HISTORIC AND DESIGN REVIEW COMMISSION

HDRC CASE NO: 2024-392
ADDRESS: 1510 E HOUSTON ST
LEGAL DESCRIPTION: NCB 576 BLK 15A LOT E 31.1 FT OF 2
ZONING: RM-4, H
CITY COUNCIL DIST.: 2
DISTRICT: Dignowity Hill Historic District
APPLICANT: FELIPE DE JESUS
OWNER: FELIPE DE JESUS/ALCALA FELIPE DE JESUS NAVARRO
TYPE OF WORK: Construction of a 1-story, single-family residential structure
APPLICATION RECEIVED: November 13, 2024
60-DAY REVIEW: January 12, 2025
CASE MANAGER: Edward Hall

REQUEST:

N
SITE PLAN
SCALE: 3/16"=1'-0"

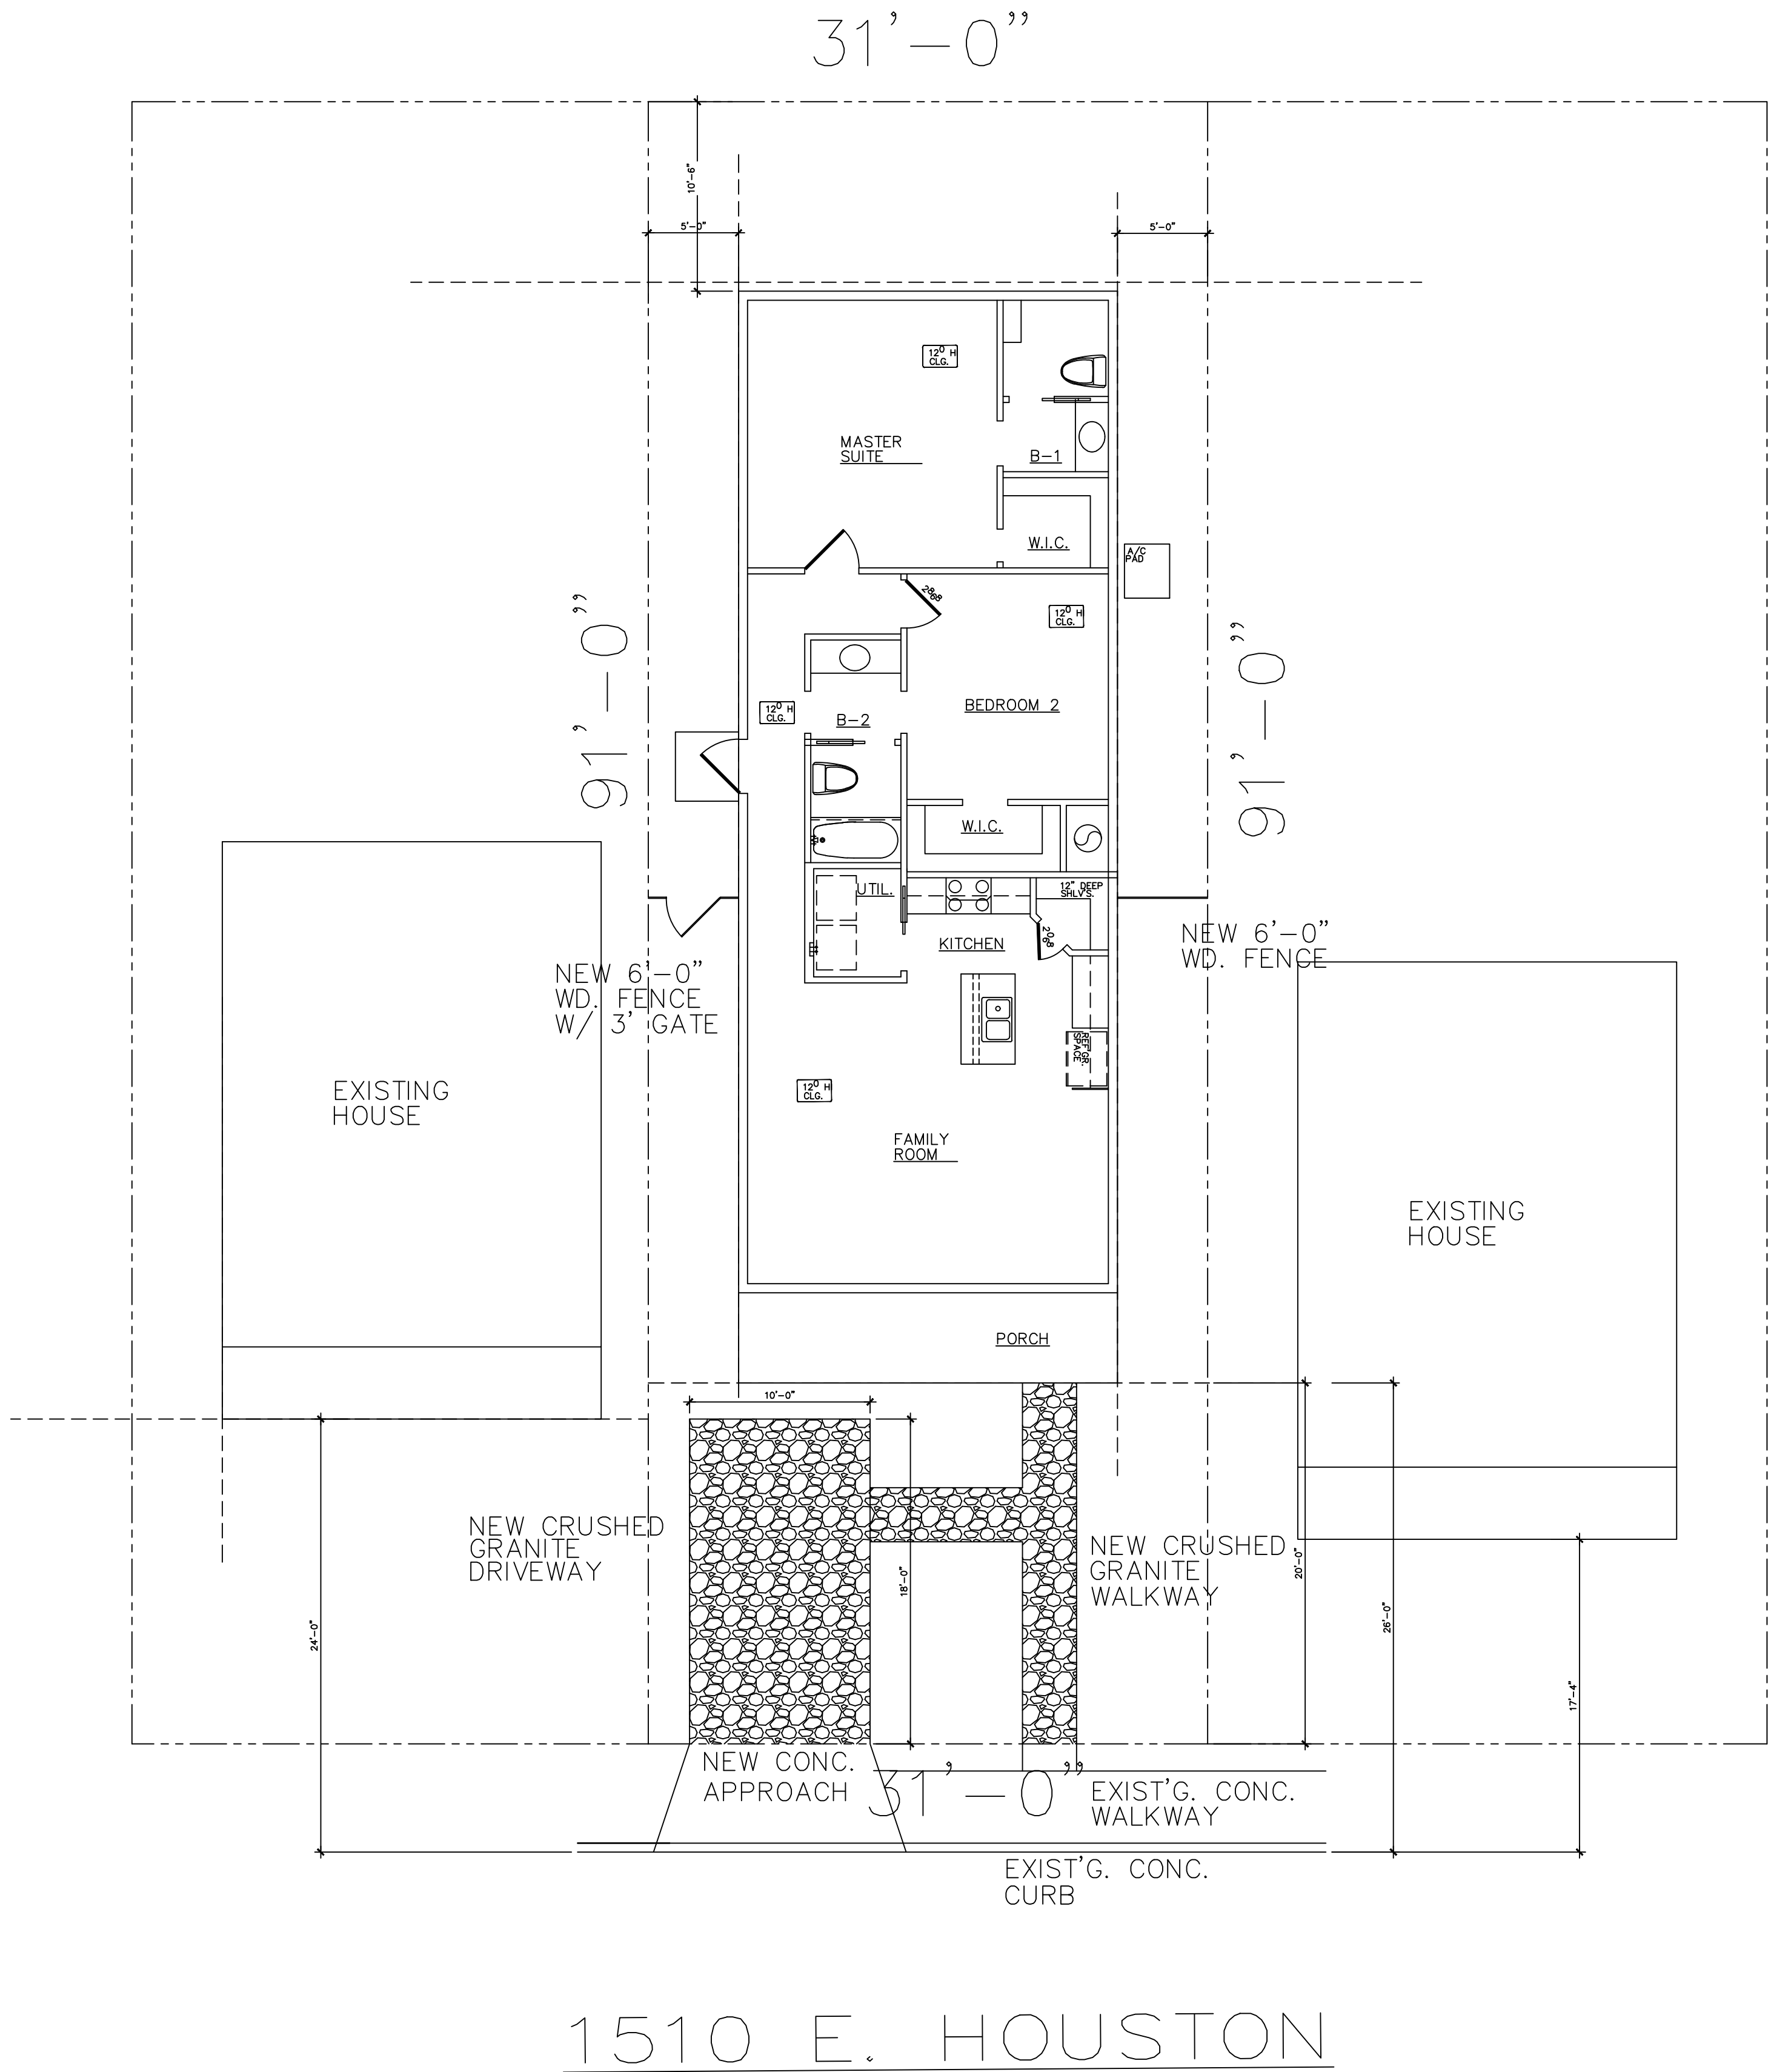
- b. **CONTEXT & DEVELOPMENT PATTERN** – The applicant is proposing new construct at 1510 E Houston Street, a lot currently void of structures. This block of E Houston currently features three (3) structures that front E Houston. Two of the structures feature one story in height. Per the submitted site plan, this lot features an overall width of 31' – 0" and an overall depth of 91' – 0".

- xii. That all mechanical equipment be screened from view from the right of way. ***This stipulation has been met.***
- d. SETBACKS & ORIENTATION – According to the Guidelines for New Construction, the front facades of new buildings are to align with front facades of adjacent buildings where a consistent setback has been established along the street frontage. Additionally, the orientation of new construction should be consistent with the historic examples found on the block. The applicant has proposed a setback of 20’ – 0” from the front property line to the front porch. Additionally, the applicant has submitted a setback diagram noting a front setback that is to exceed both the front setbacks of the adjacent historic structures. Staff finds the proposed setback to be appropriate and consistent with the Guidelines.

- a. LOT COVERAGE – The applicant has not provided a building to lot ratio. Per BCAD records, this lot features 2,944 square feet in size. Per the submitted site and floor plan, the applicant has proposed a footprint of 1,270.5 square feet. The Guidelines for New Construction 2.D.i. notes that new construction should be consistent with adjacent historic buildings in terms of the building to lot ratio. Footprints of new construction should be limited to no more than fifty (50) percent of the total lot area, unless adjacent historic buildings establish a precedent with a greater building to lot ratio. Staff finds the proposed footprint to be appropriate and consistent with the Guidelines.

- p. DRIVEWAY & FRONT YARD PARKING – The applicant has proposed to install both a curbcut and driveway to provide vehicular access from E Houston Street into the property. Given the narrow width of the lot, the proposed driveway will terminate into the front façade of the proposed new construction and will create a front yard parking condition. While front yard parking is not in keeping with the Guidelines, staff finds that given the lack of additional space for a side driveway and parking location, the proposed driveway and parking configuration is appropriate. The applicant has proposed for the driveway to feature decomposed granite paving and a width of ten (10) feet.

- q. WALKWAY – The applicant has noted a walkway leading from the front porch to the sidewalk at the right of way. The Guidelines for Site Elements 5.A.iii. notes that the historic alignment, configuration and width of sidewalks and walkways should be followed. Historically, walkways within the Dignowity Hill Historic District are concrete. Staff finds that the proposed walkway leading from the front porch to the sidewalk at the right of way should be concrete. The walkway element connecting the driveway to the primary walkway may be decomposed granite.

- ii. That a dimensioned column detail be submitted for OHP staff review and approval.
- iii. That a detailed landscaping plan be submitted for OHP staff review and approval.
- iv. That the front walkway leading from the front porch to the sidewalk at the right of way feature concrete, as found consistently within the historic district.

FRONT ELEVATION
SCALE: 1/4" = 1'-0"

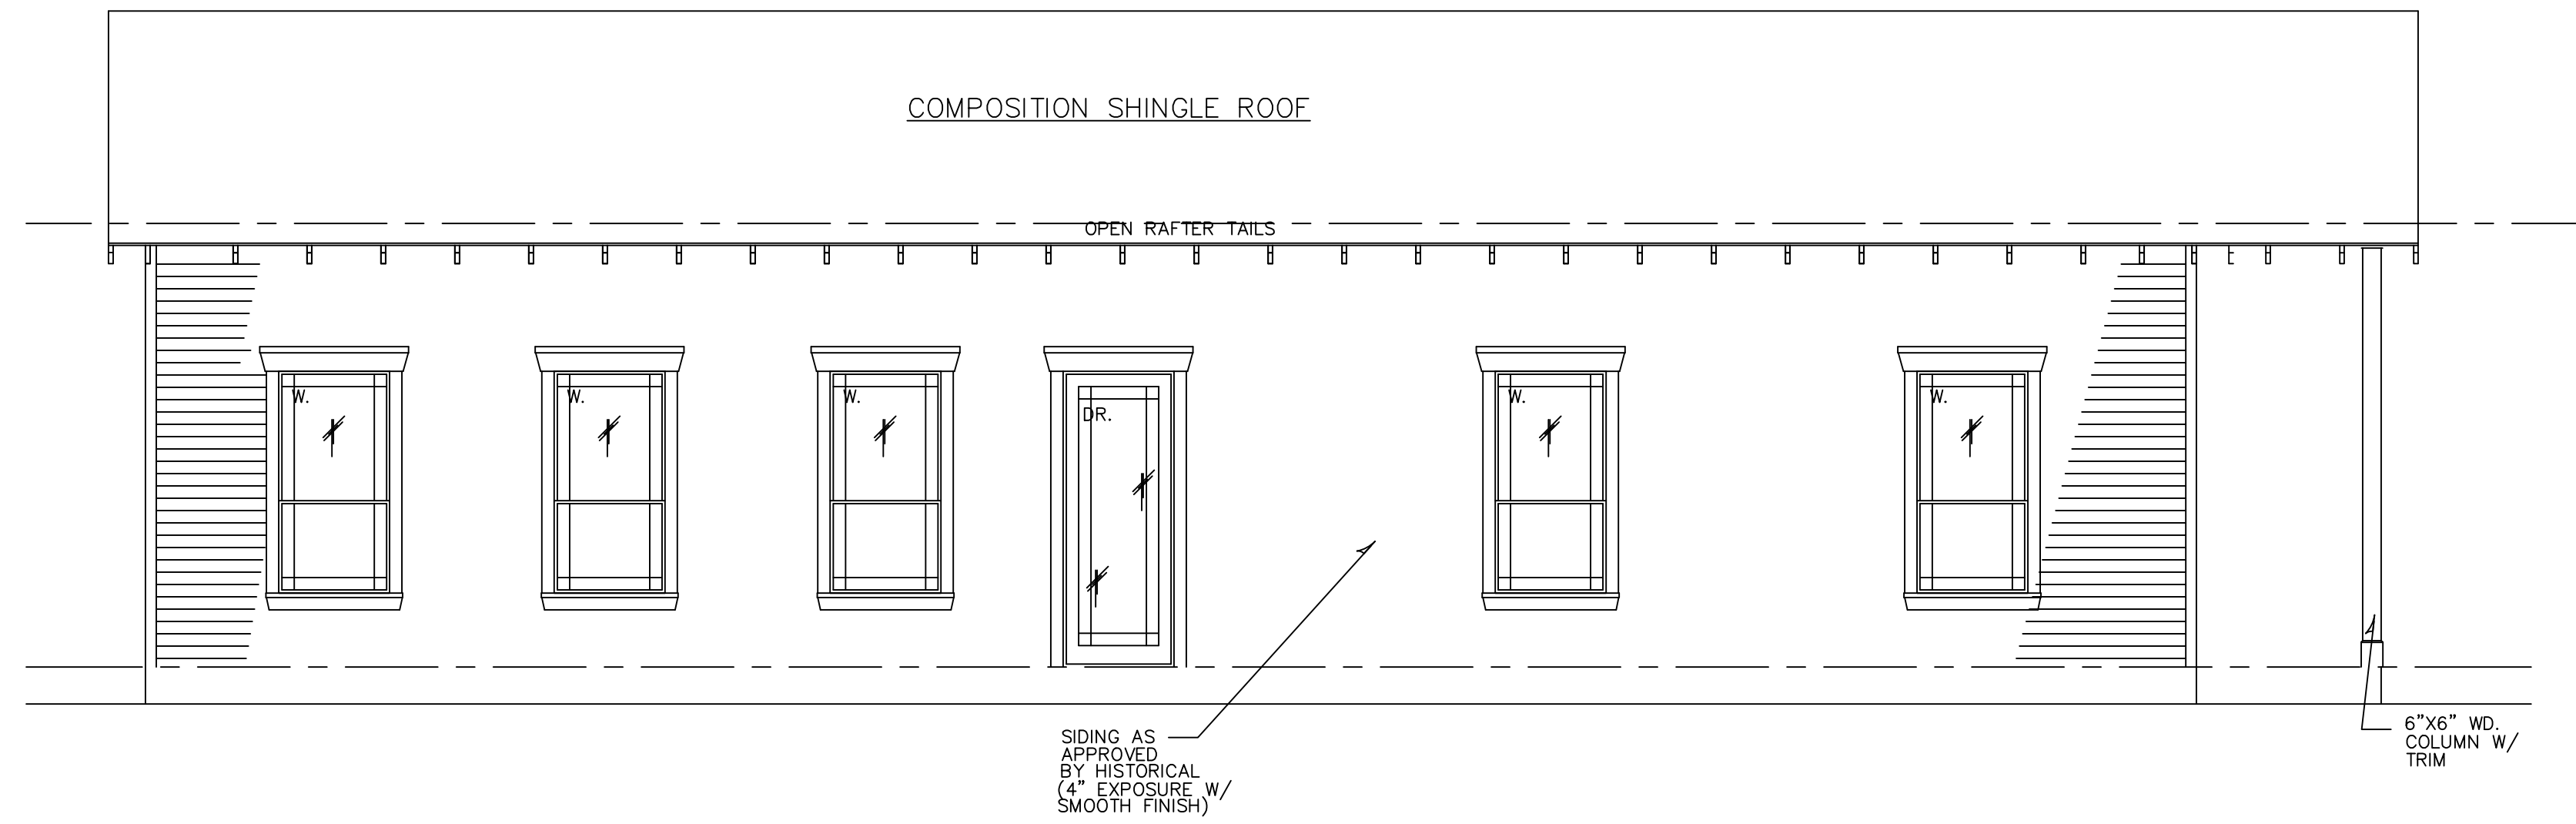
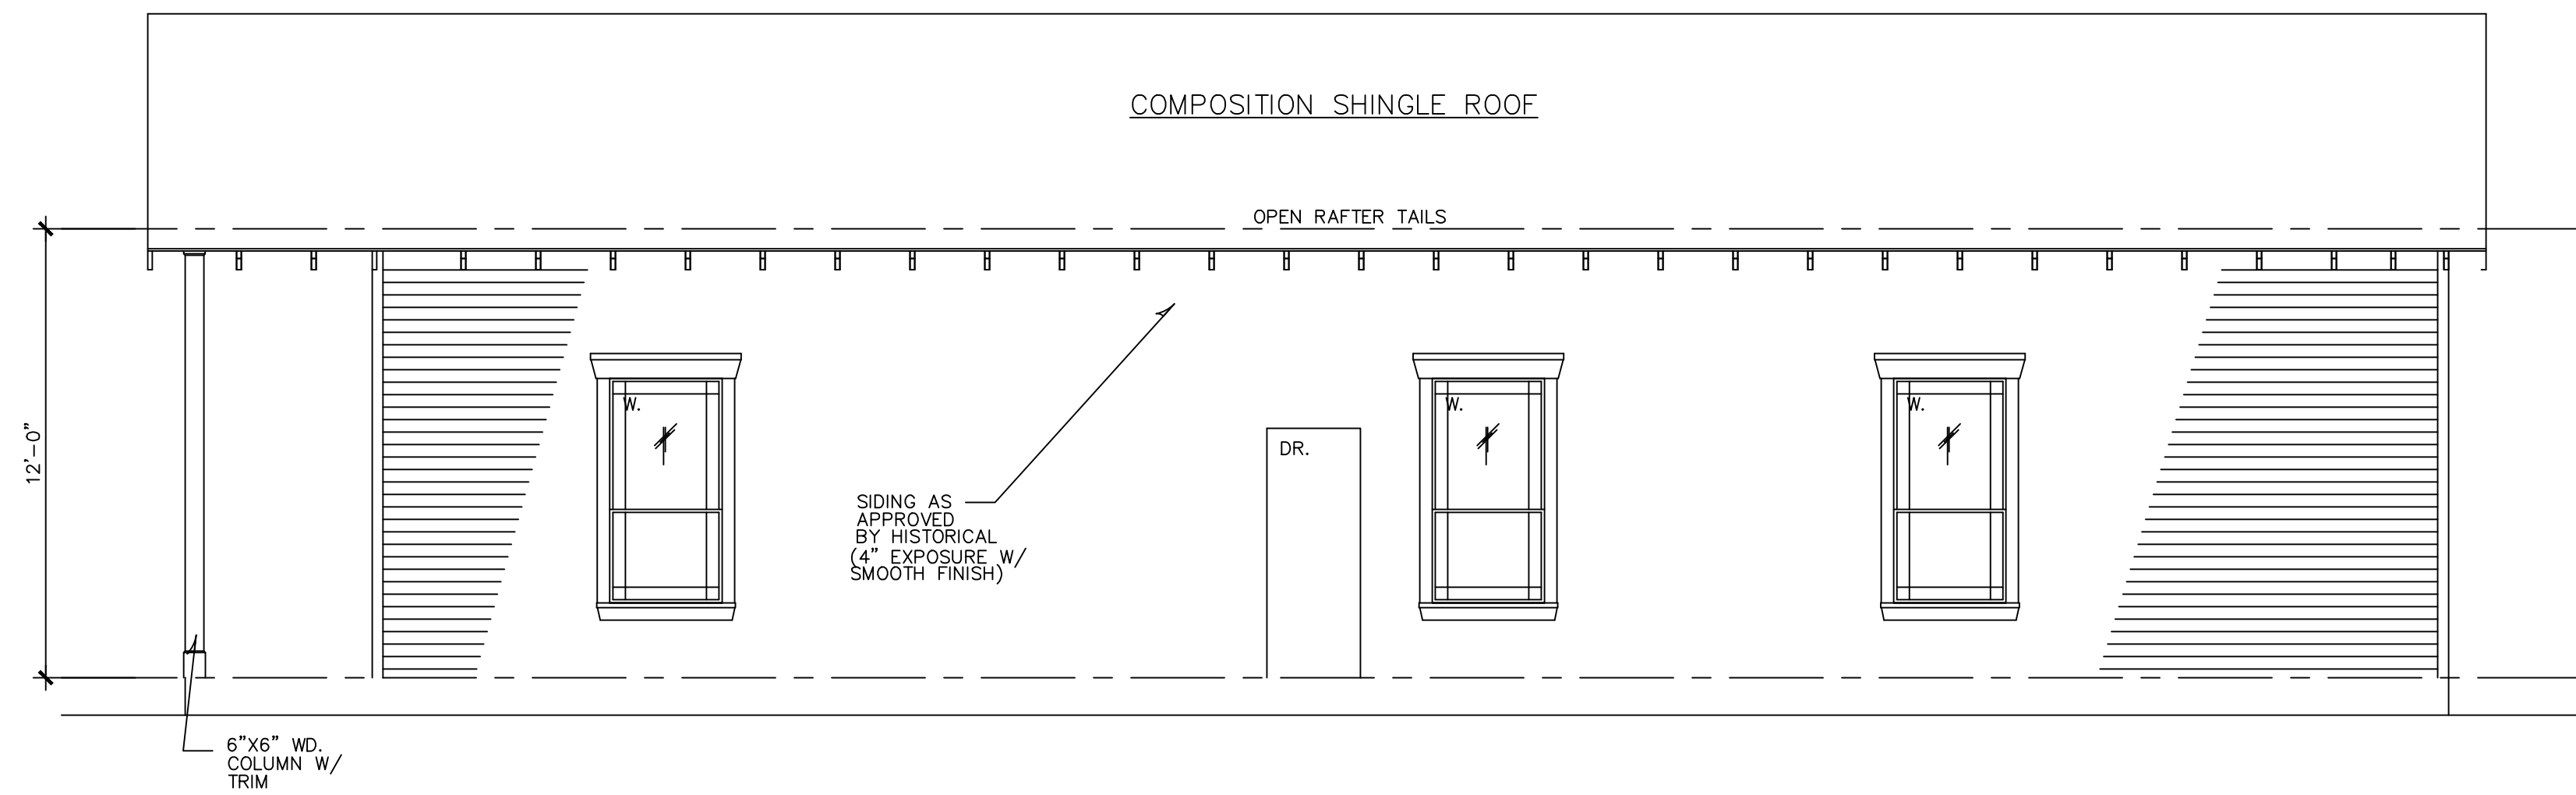
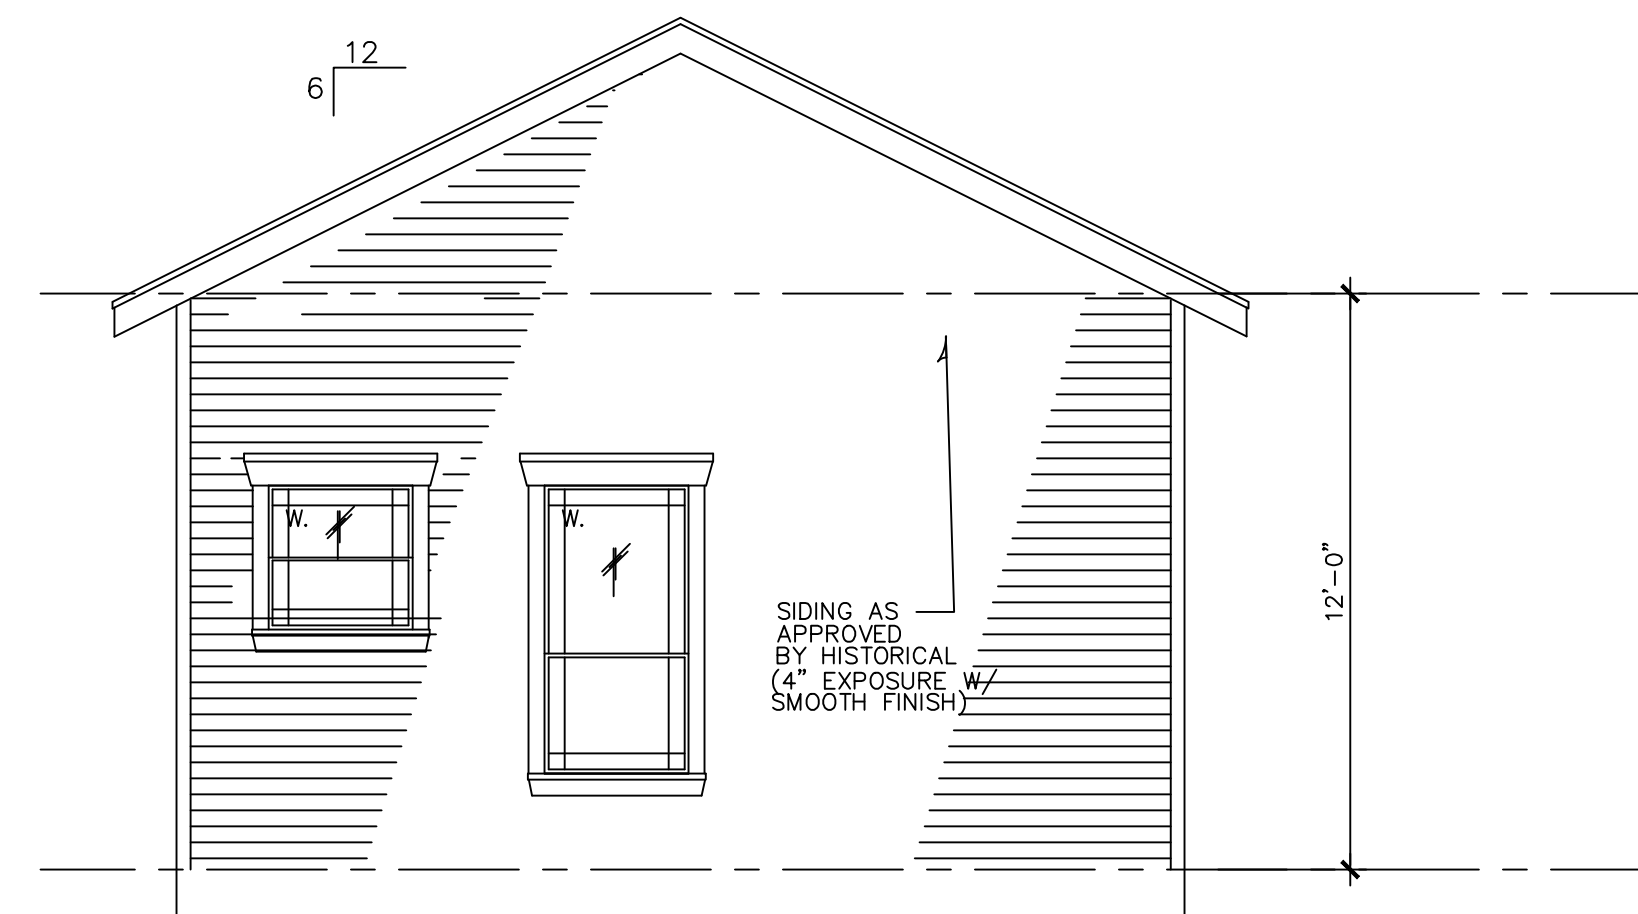
- vii. That wood or aluminum clad wood windows be installed, and that windows adhere to the adopted window standards. Windows should feature one over one profiles with equally sized sashes and no transom windows. Additionally, staff recommends that the proposed transom window above the front entrance roof be modified to relate to historically sized and proportioned transom windows. ***This stipulation has not been met.***

- ix. That columns that are six (6) inches square with capital and base trim be installed. If tapered, Craftsman style columns are proposed, a dimensioned column detail should be submitted for review and approval. ***This stipulation has not been met.***

- j. WINDOW MATERIALS – The applicant has not proposed window materials at this time; however, per the submitted construction documents the applicant has proposed window profiles that are atypical of the style and profile of windows found historically within the district. Staff finds that all window should feature one over one profiles with equally sized sashes. Additionally, staff finds that windows should adhere to the adopted standards for windows in new construction. These standards are noted in the applicable citations.

- l. PORCH DESIGN – The applicant has proposed a porch that features massing that is incorporated into the overall massing of the proposed new construction. The applicant has proposed wood columns that are six inches square with capital and base trim. Generally, staff finds the proposed porch and column design to be appropriate and consistent with the Guidelines.

- i. That wood or aluminum clad wood windows be installed, as noted in finding j and that windows adhere to the adopted window standards. Windows should feature one over one profiles with equally sized sashes.
